23 Harry Lee Crescent Consultants Declaration:

Zoning Information: R1-71

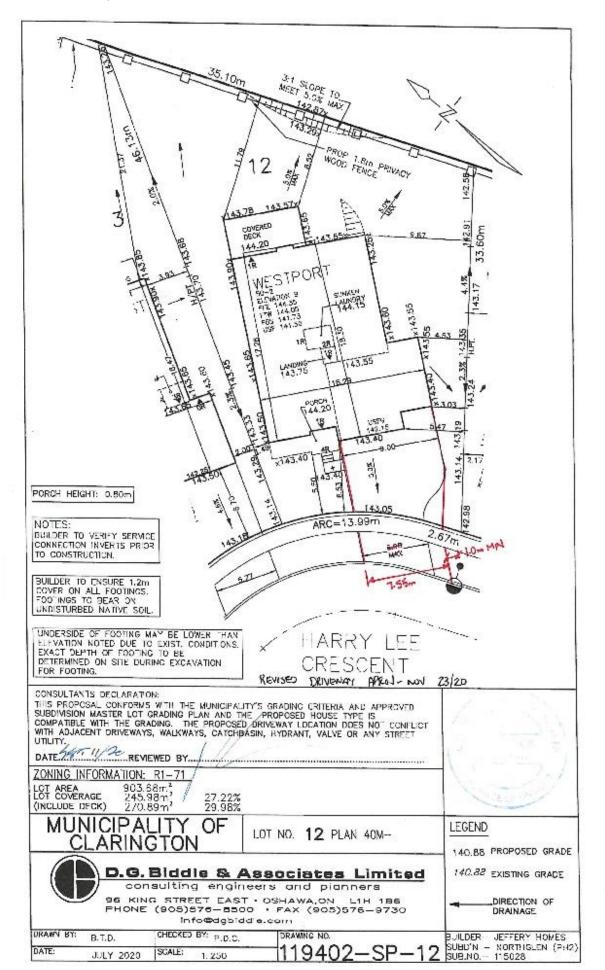
Please note on Drawing that it says
Three Car Garage
